Westinghouse  
Electric Company

DCP/NRC 1481

Subject: AP1000 Pre-Application Review – Acceptance Review of Codes Submission  
and Responses to Requests for Additional Information pertaining to the AP1000  
Pre-Certification Review

## AP1000 PRE-CERTIFICATION REVIEW

Figure 004-1

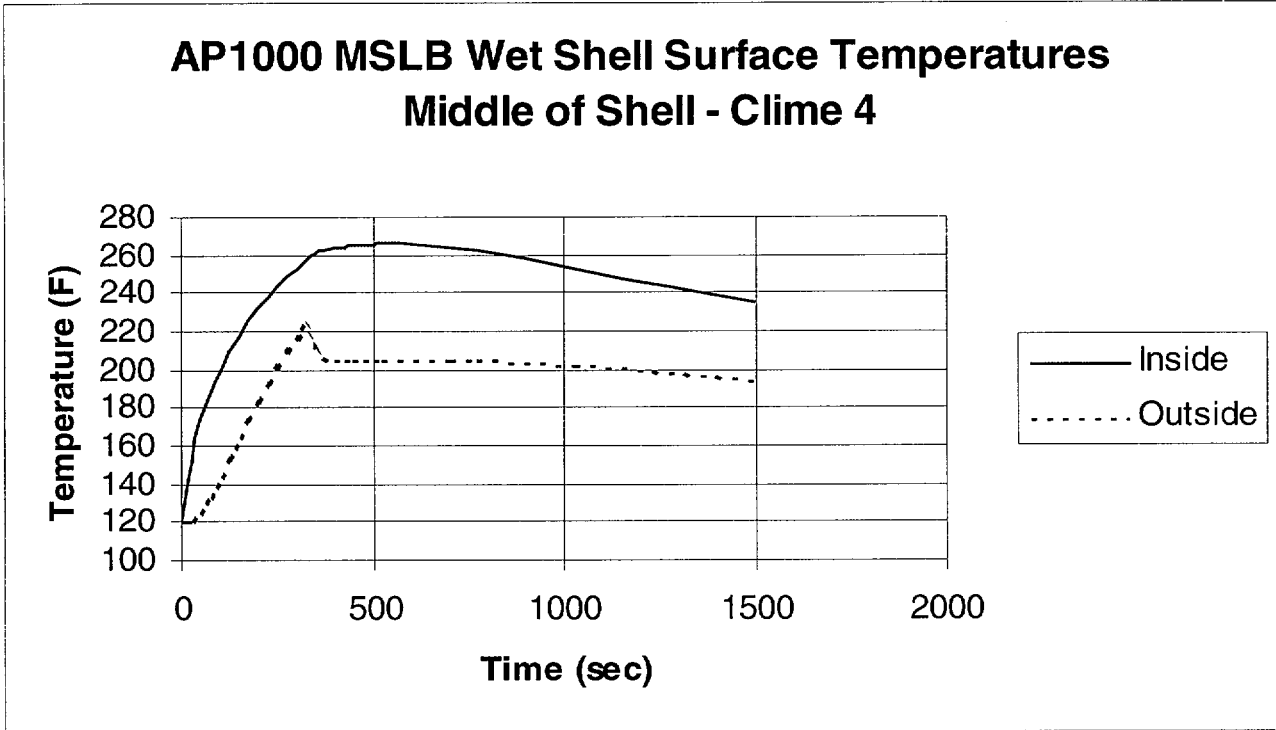
- P4 (b) The shell temperatures for the steam line break rather quickly exceed the boiling temperature on the outside of the shell. The results of a sensitivity study with no PCS water were shown. Does this mean that Westinghouse will take no credit for PCS water in the steam line break licensing analysis, and only credit heat transfer through the dry shell? Given the high temperature how will Westinghouse justify compliance with GDC 38?

Figure 3.4-9 of WCAP-15612 presents the AP1000 scoping analysis results for the shell inside surface temperature transient of a representative clime during an MSLB event. Figure P004-1 presents a comparison of the Clime 4 inside and outside shell surface temperature transients from the scoping analysis model. The application of PCS water causes the outer surface temperature to rapidly decrease and subsequently remain below the boiling point. As shown in Figure P004-2, the AP1000 wet shell temperature response for the MSLB event is similar to the AP600.
